| PROJECT TITLE AND LOCATION Holcomb Blvd Water Treatment Plant | | |
| MCB, Cp Lejeune, North Carolina | | |

| ITEM NO. | PROJ. SPEC. SECT. & PARA. and/or PROJ. DWG. NO. | ITEM IDENTIFICATION (Type, size, model no., Mfg. name, dwg. or brochure number) | NO. OF COPIES | ACTION CODES | REVIEWER'S INITIALS CODE AND DATE |
|----------|---|---|---------------|--------------|-----------------------------------|
| | 02734 | ROTARY DRILLED WATER WELLS | | | |

RE: N62470-81-C-1644
Expansion of Holcomb Blvd.
Water Treatment Plant
Camp Lejeune, NC 28542
Well #10

CHARACTERISTIC CURVES

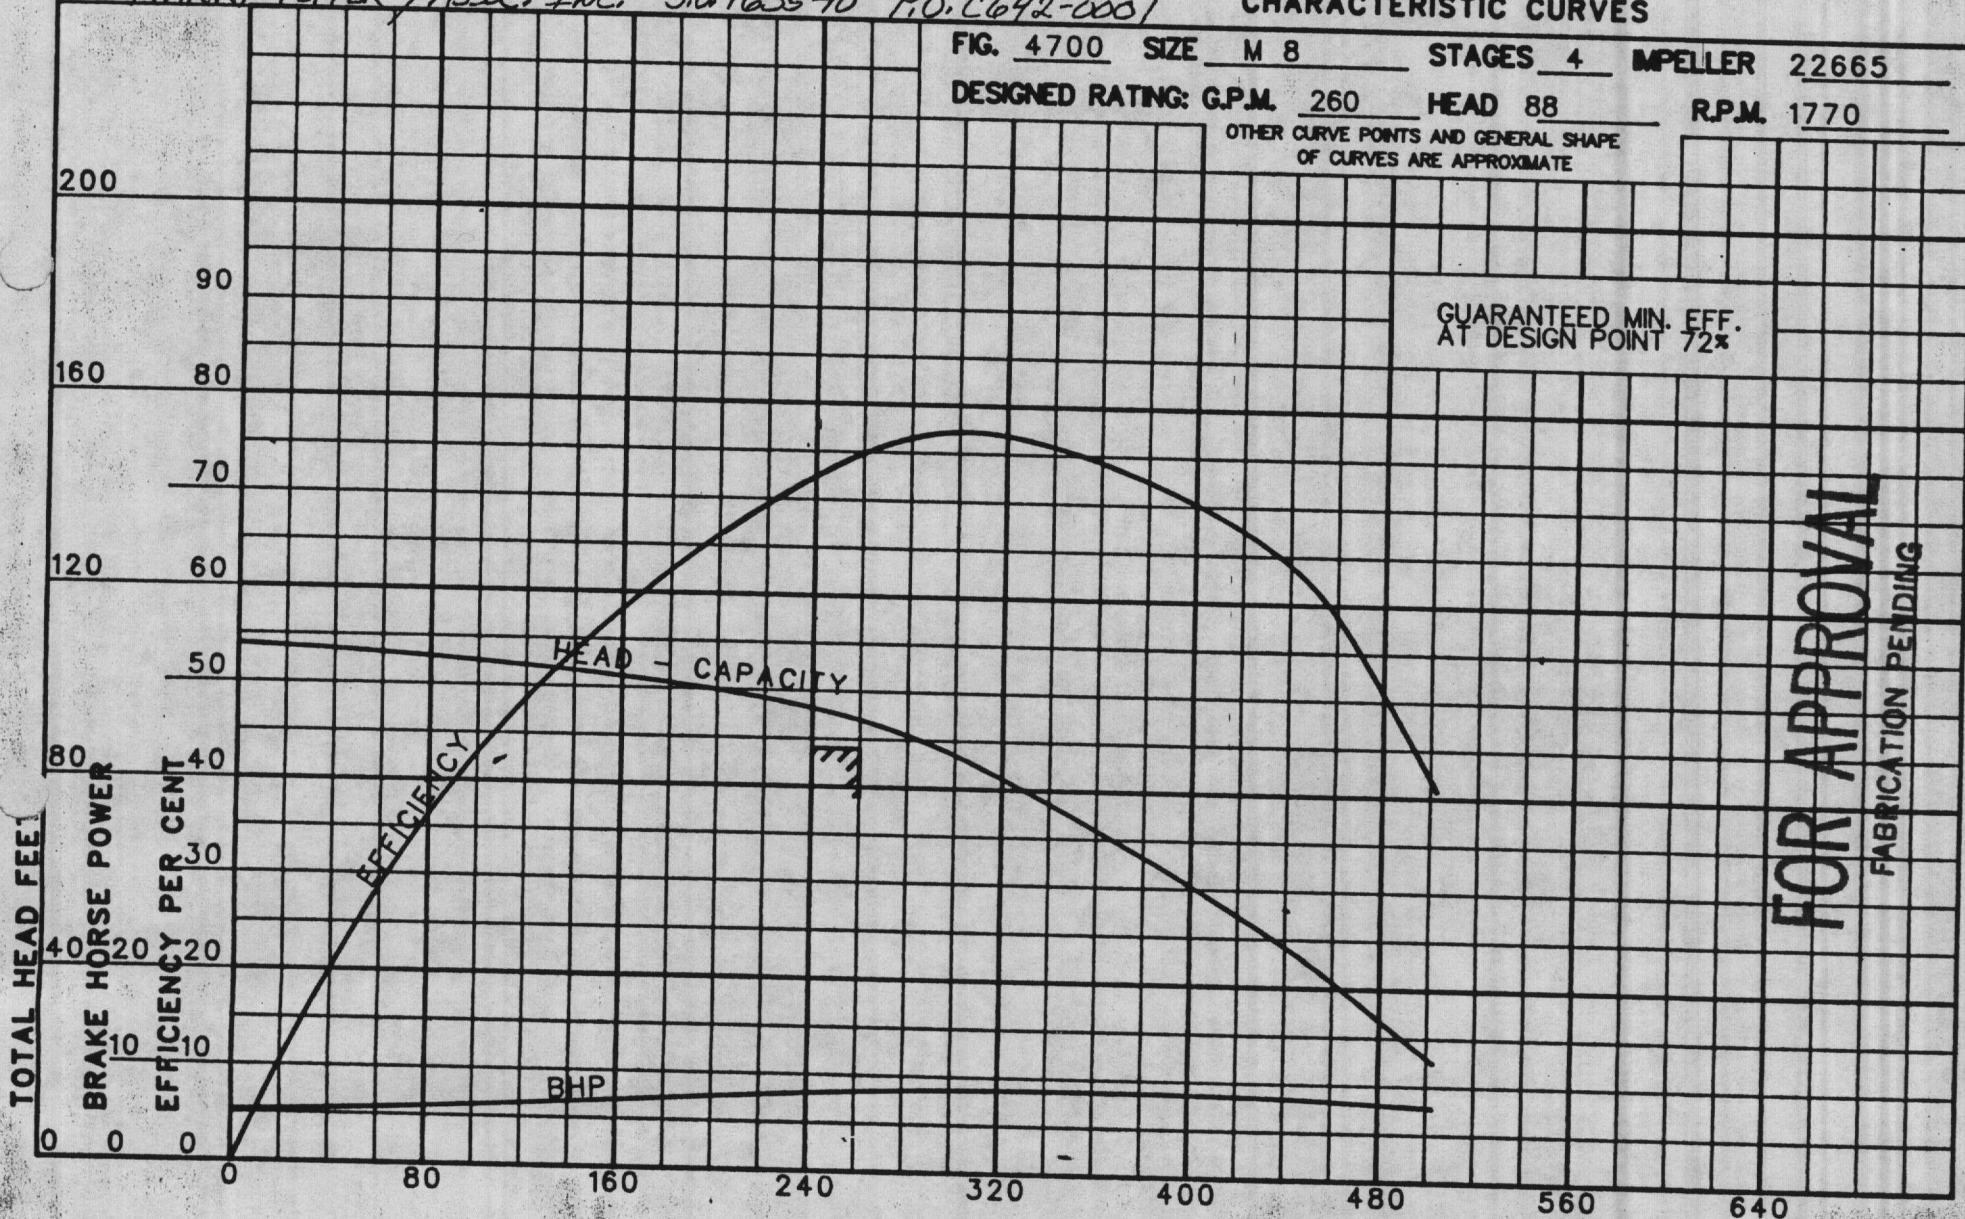
DESIGNED RATING: G.P.M. 260 HEAD 88 R.P.M. 1770

GUARANTEED MIN. EFF. AT DESIGN POINT 72*

FOR APPROVAL
FABRICATION PENDING

DRAWING NO. **T82517**

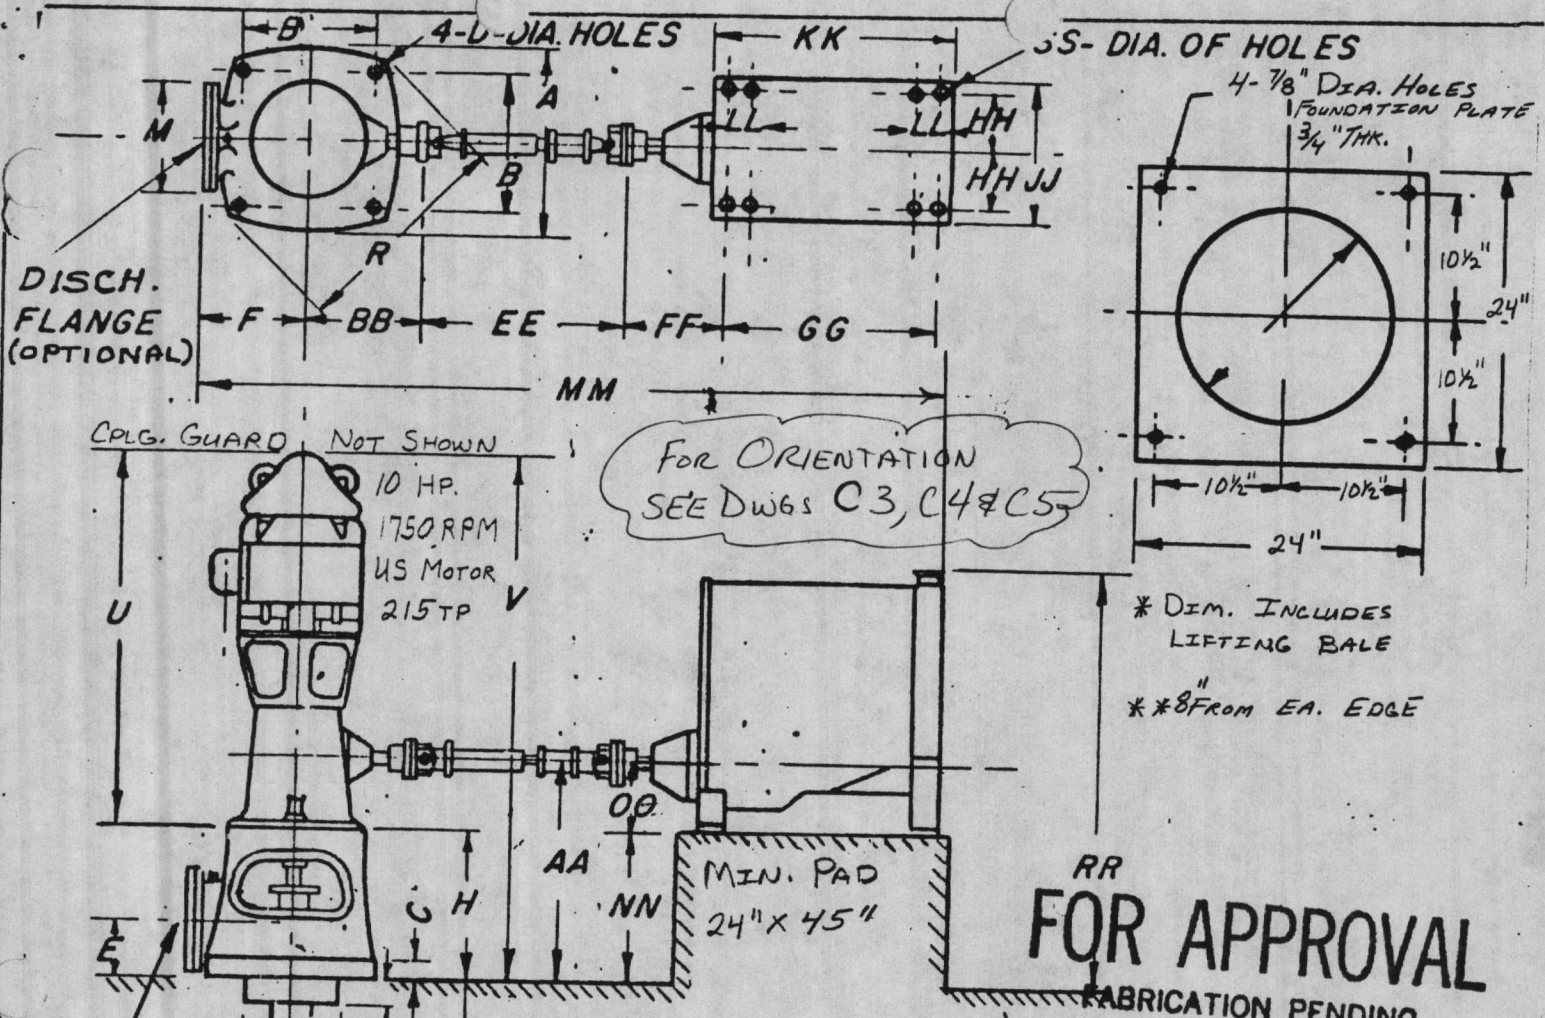
FOR ORIENTATION SEE DWGS C3, C4 & C5

RR FOR APPROVAL
